Project File Number: SSE-1336-K
 Coffman Cove Timber sale
 Forest Land Use Plan
 Amendment 1

The Forest Land Use Plan is modified as follows:

ATTACHMENT A2
SSE-1336K
COFFMAN COVE
TIMBER SALE
UNIT
7

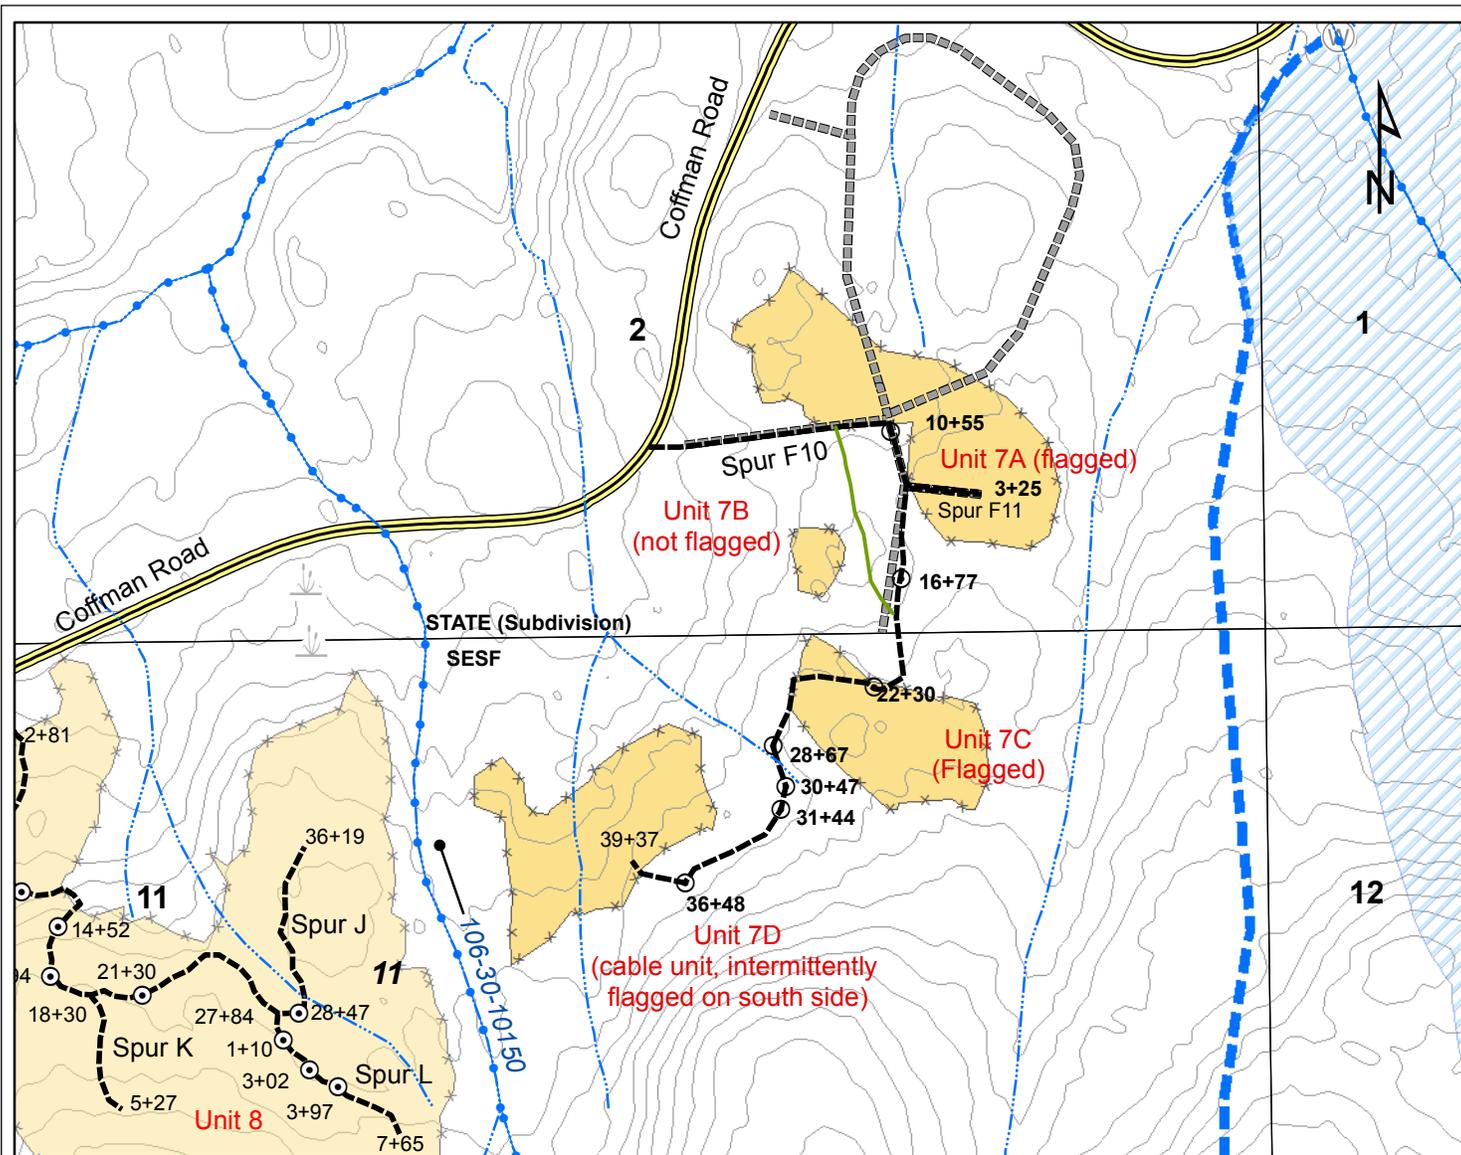
Replace Attachment A2 Timber Sale Unit 7 dated 12/06/2016 with the attached map titled the same and dated 2/14/2017.
